BMP NUMBER: **MC062**

SITE PLAN
FOR
MARYWOOD SUBDIVISION
JAMES CITY COUNTY, VIRGINIA

RECORD DRAWINGS
ST. BEDE CHURCH
PRAYER GARDEN
"RAIN TANKS"
JAMES CITY COUNTY, VA
9/05/06
SHEET 1 OF 2

Project Number	22067
File	
Date	09/12/03
Drawn	
Reviewed	
Sheet	C1.0

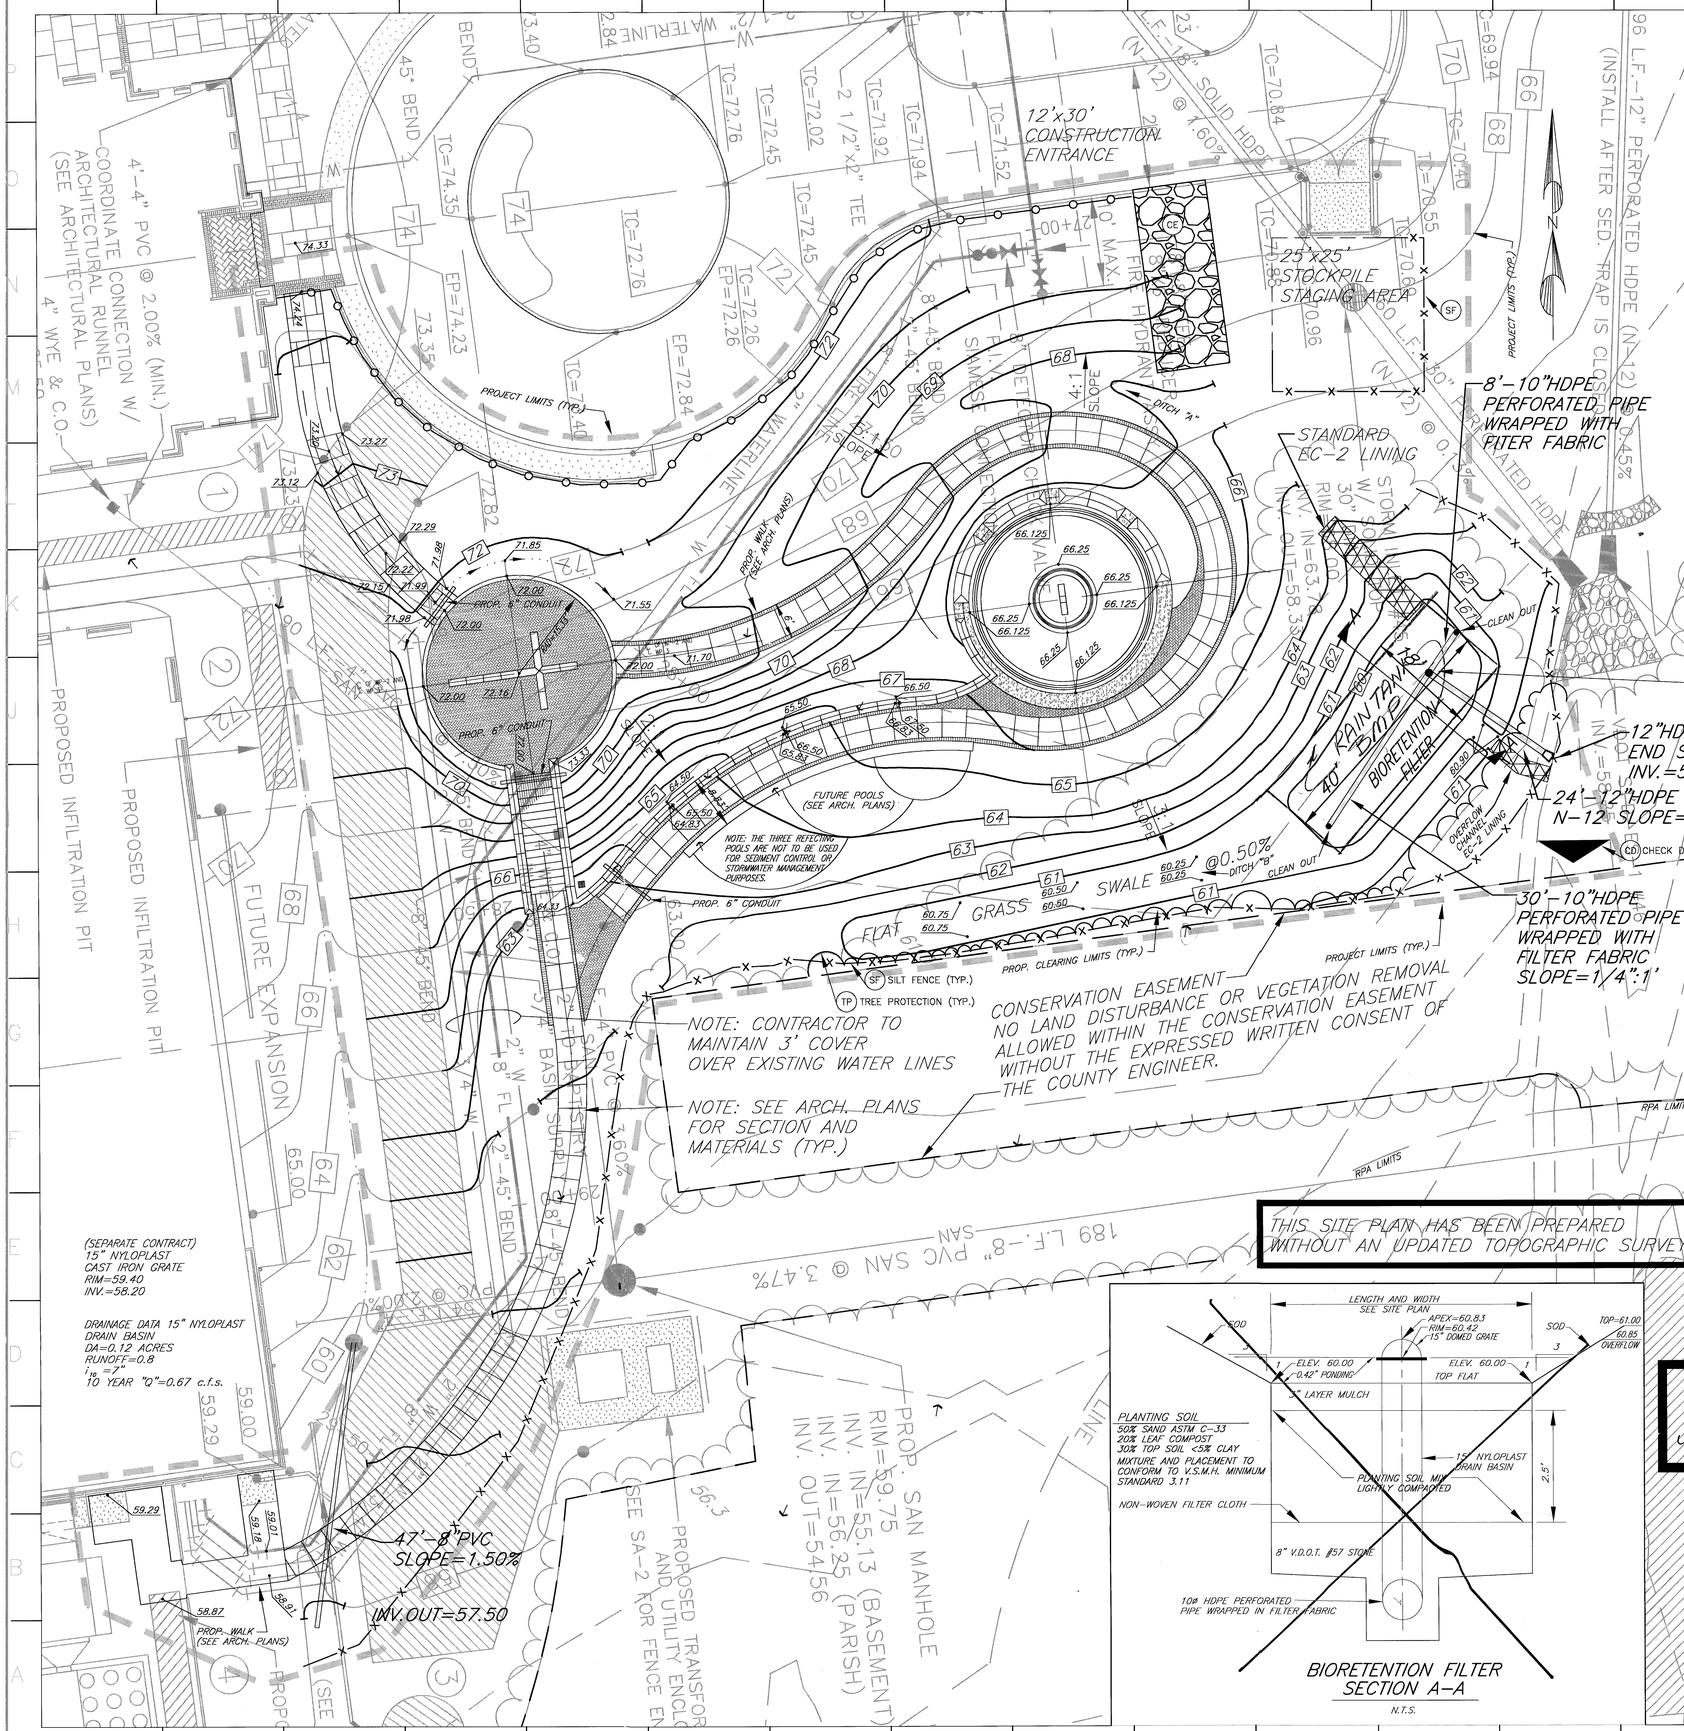
11. ✓ Limits of Work. Show and label a distinct limit of work (clearing and grading) around the site periphery. Be sure to include work associated with installation of erosion and sediment control measures. Limits of landscaping as shown on landscaping sheet L1.1 are not consistent with the limit of work indicated on Sheet C1.0, especially in the area of the bioretention basin.

12. ✓ Sequence of Construction. Provide a sequence of construction outlining installation of erosion and sediment control measures for the project, including removal of the existing sediment trap to the northeast of the prayer garden, if this feature is still in place during the time of construction of this site. sheet C1.0

19. ✓ Channel. Just south of the "three pool" reflecting pond water features, plan Sheet C1.0 shows a drainage swale along the northern limit of the conservation easement area. This stormwater conveyance channel cannot just dead end onto a flat slope. The channel configuration must discharge into an adequate channel or receiving facility in conformance with the provisions of Minimum Standard 19 of the Virginia Erosion and Sediment Control regulations.

11. ✓ Limits of Work. Show and label a distinct limit of work (clearing and grading) around the site periphery. Be sure to include work associated with installation of erosion and sediment control measures. Limits of landscaping as shown on landscaping sheet L1.1 are not consistent with the limit of work indicated on Sheet C1.0, especially in the area of the bioretention basin.

12. ✓ Sequence of Construction. Provide a sequence of construction outlining installation of erosion and sediment control measures for the project, including removal of the existing sediment trap to the northeast of the prayer garden, if this feature is still in place during the time of construction of this site. sheet C1.0

19. ✓ Channel. Just south of the "three pool" reflecting pond water features, plan Sheet C1.0 shows a drainage swale along the northern limit of the conservation easement area. This stormwater conveyance channel cannot just dead end onto a flat slope. The channel configuration must discharge into an adequate channel or receiving facility in conformance with the provisions of Minimum Standard 19 of the Virginia Erosion and Sediment Control regulations.

11. Clearing and/or construction limits are shown on sheet C1.0.
